# **Eielson Air Force Base Operable Units 3, 4, and 5**

## **Declaration of the Amended Record of Decision**

Operable Units 3, 4, and 5  
Eielson Air Force Base, Alaska

**AMENDMENT OUTLINE  
 OPERABLE UNITS 3,4,5 RECORD OF DECISION  
 EIELSON AIR FORCE BASE  
 SOURCE AREAS DP44, SS35, ST58, & LF03/FT09**

ST58: TI-Waiver Boundary, Eielson AFB, Alaska

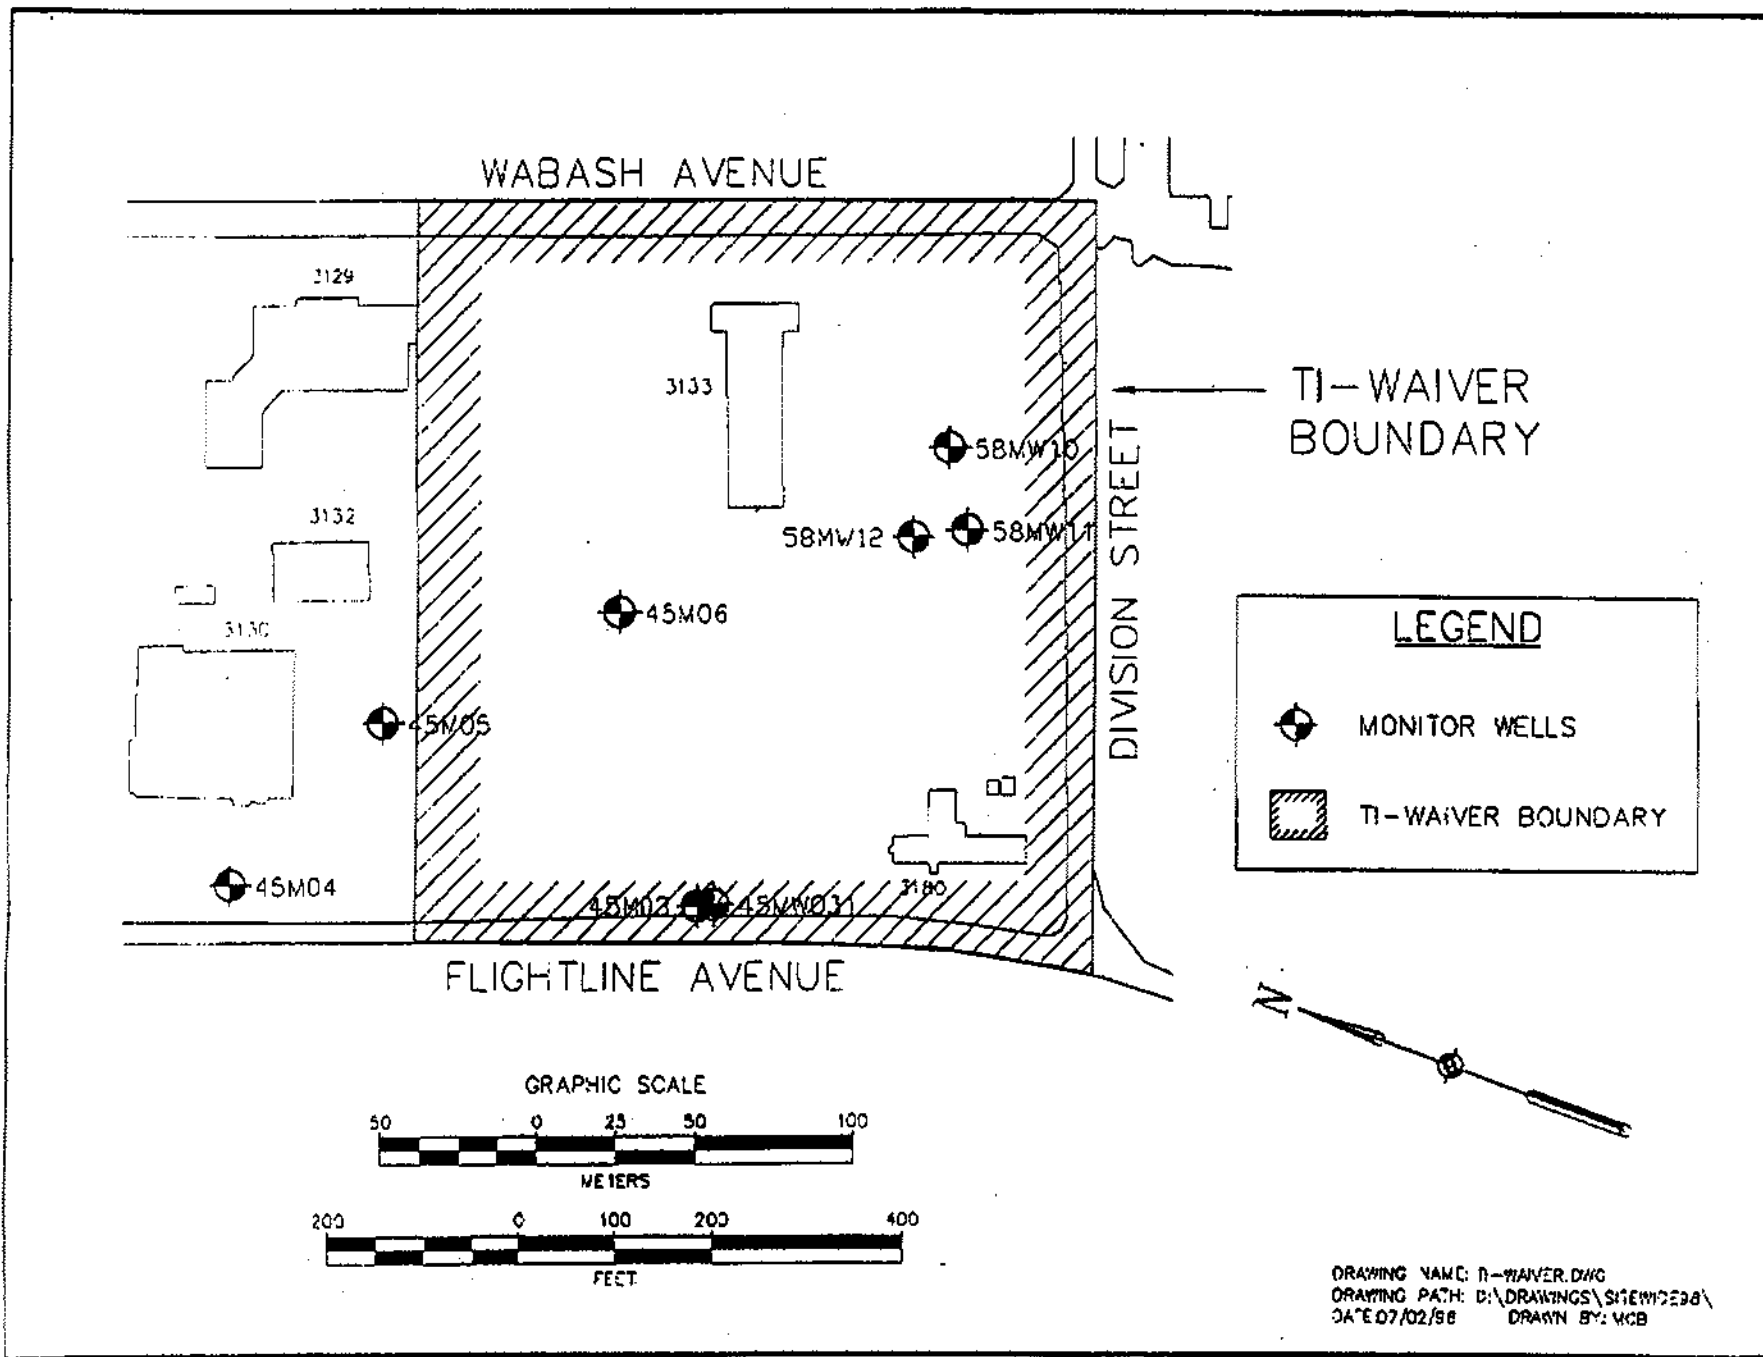
The TI waiver will apply to the area having the following boundaries (see Figure A).

FIGURE 2  
CONCEPTUAL SITE MODEL  
EIELSON AIR FORCE BASE

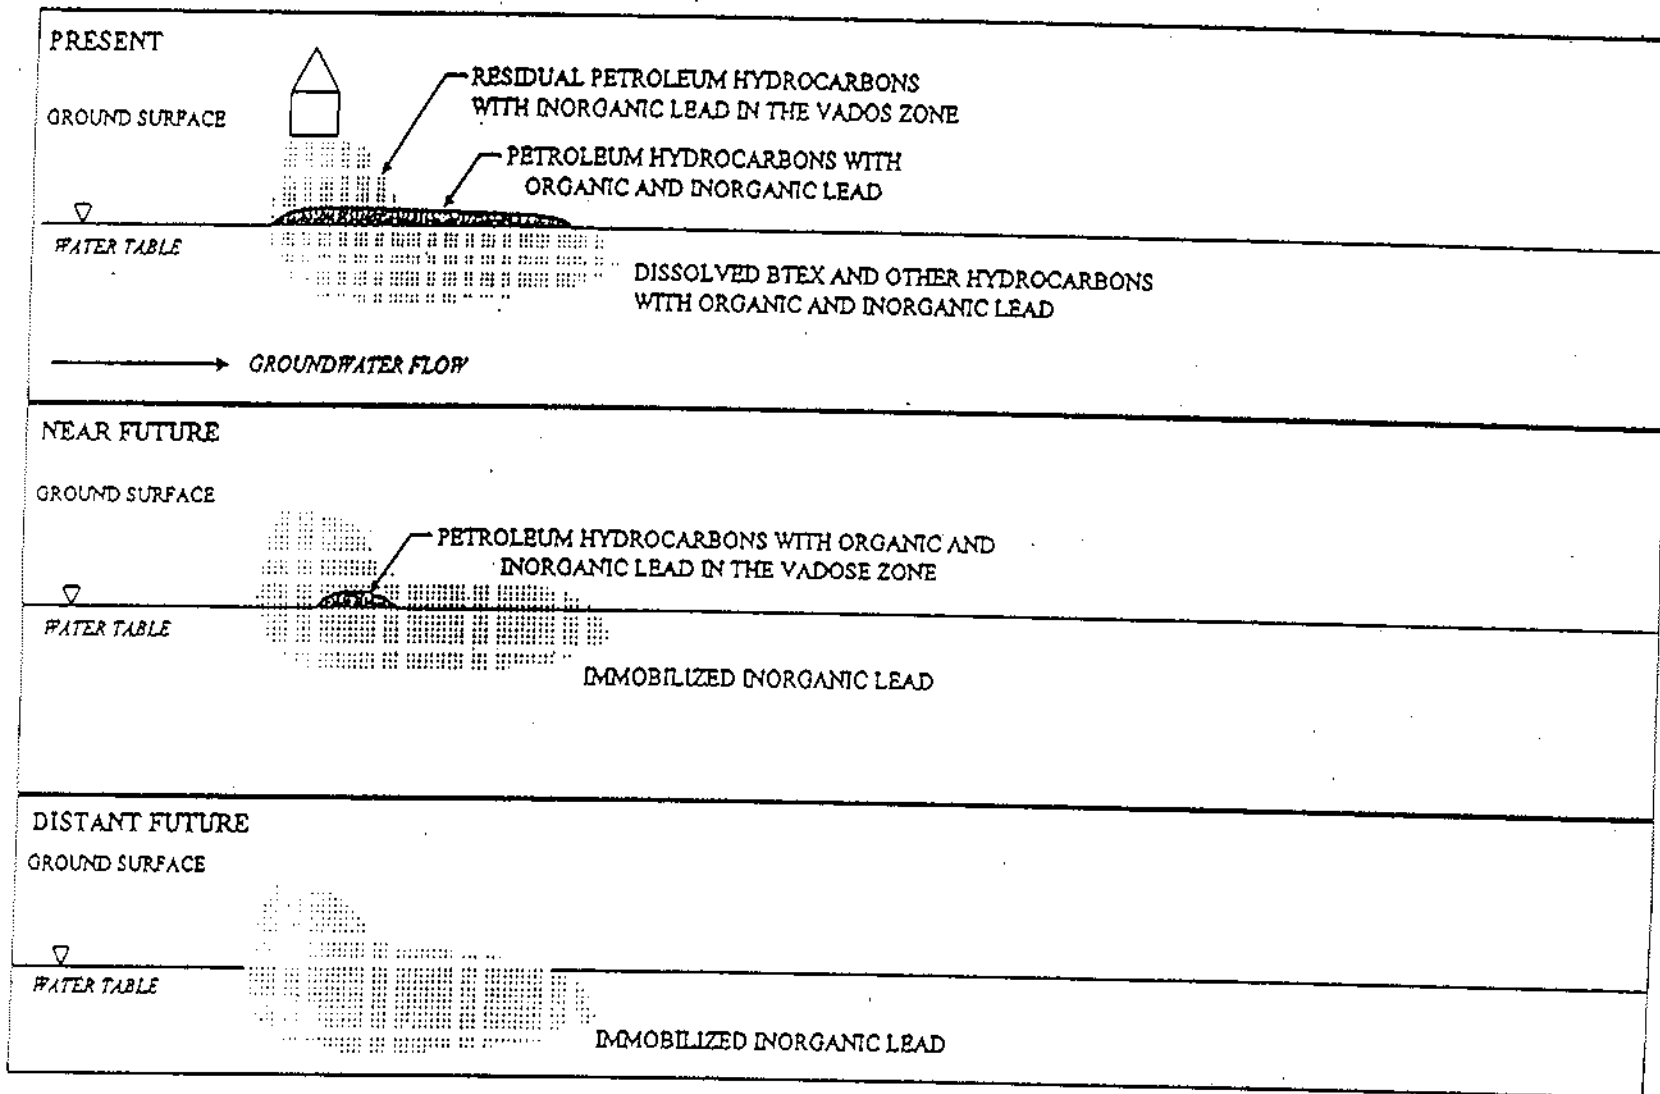
The investigation indicates that the major source of lead contamination is from the floating product plume as shown in Figure 2. The lead plume is confined to a small area north of the above ground storage tanks at DP26 and appears to coincide with the historic extent of the floating product plume. During the investigation, tetraethyl lead (TEL), the organic lead fuel additive, was detected in a floating product sample at a level of 319,000 ug/L and at low levels in the groundwater, i.e., 6 ug/L (page ES-3). The groundwater TEL plume was coincident to that of inorganic lead. The investigation also established that the lead contamination is confined to depths between 5 and 30 feet below ground surface (page 5-3).
